SUBJECT:Class II Permissive Charge for FCC ID: 2AP3Q-FG2431WB

The product,: Smart Body Fat Scale, has been granted by FCC dated 05/30/2025,
FCC ID: 2AP3Q-FG2431WB.Now we, Guangdong Welland Technology Co., Ltd.,
would like to modify the authorized equipment for below changes:

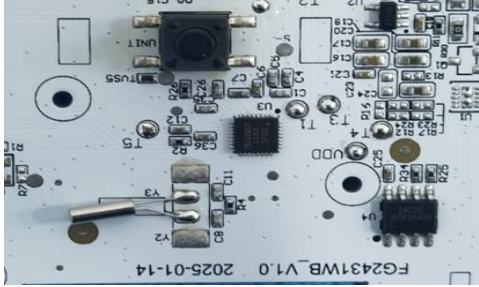
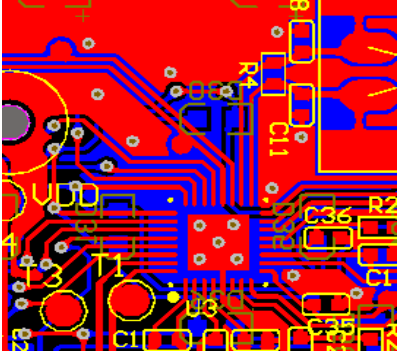
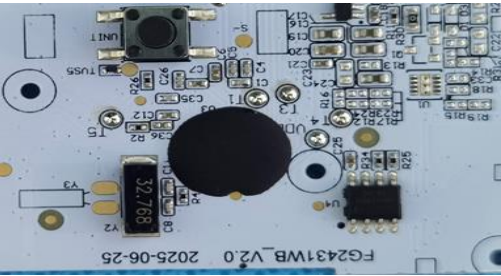
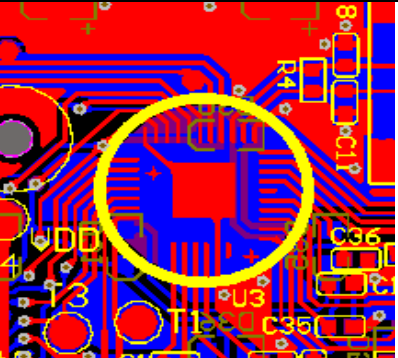
-Added series model: FG2431WB-1(The difference between FG2431WB-1 and
FG2431WB lies in the chip packaging of the MCU, which does not affect the radio
frequency function)

FG2431WB difference table					
model	PCB board full view		ifference detail view	Detailed description of the difference	
Old board				Motherboard model: FG2431WB_V1.0	U3 is an encapsulated chip Y3 The crystal oscillator adopts a plug-in package
New board				Motherboard model: FG2431WB_V2.0	U3 is a bare chip Y2 The crystal oscillator adopts a surface-mount package
